9903, 9905, 9907 & 9919 - 80 Avenue NW

To allow for a mid and high rise building with a public plaza and limited commercial uses.

Re: **Mill 99 at Richie (RZ)**
Michelle Ouellette- Latitude Consulting

Site Plan from proposed DC2 Provision

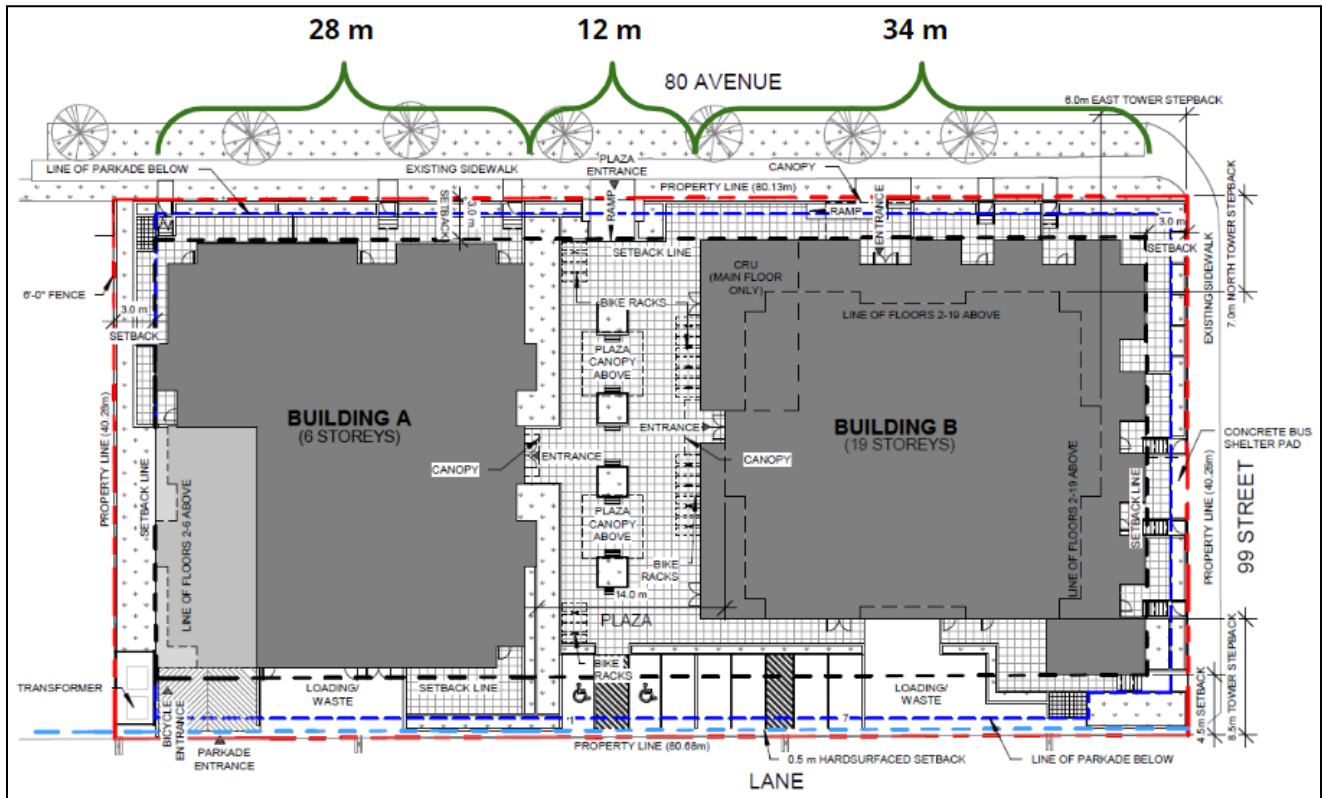
The proposed DC2 Provision addresses this concern by splitting the development into two buildings and separating them by a publicly accessible plaza/open space. The approximate lengths of the facades along 80 Avenue NW are 28 and 34 metres, with approximately 12 metres between the buildings. To achieve the desired density, this results in one of the buildings being a high rise, but it also allows for variation in sun

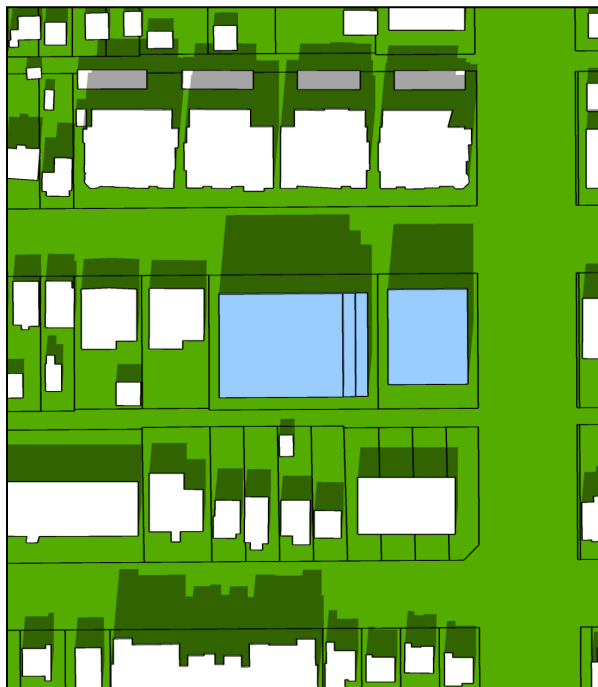
When considering the compatibility of the proposed 19 storey building, there are a number of factors to consider about its design, including the scale of the podium, its transition to the tower, and the tower floor plate. While the overall height is also a consideration, it is less important than the features closer to ground level or the overall scale of the building. This development proposes a two storey podium, which creates a human scaled street wall in the adjacent public realm. Combined with appropriate setbacks to the tower above the podium of 3 to 4 metres, the massing of the tall building transitions well to street level.
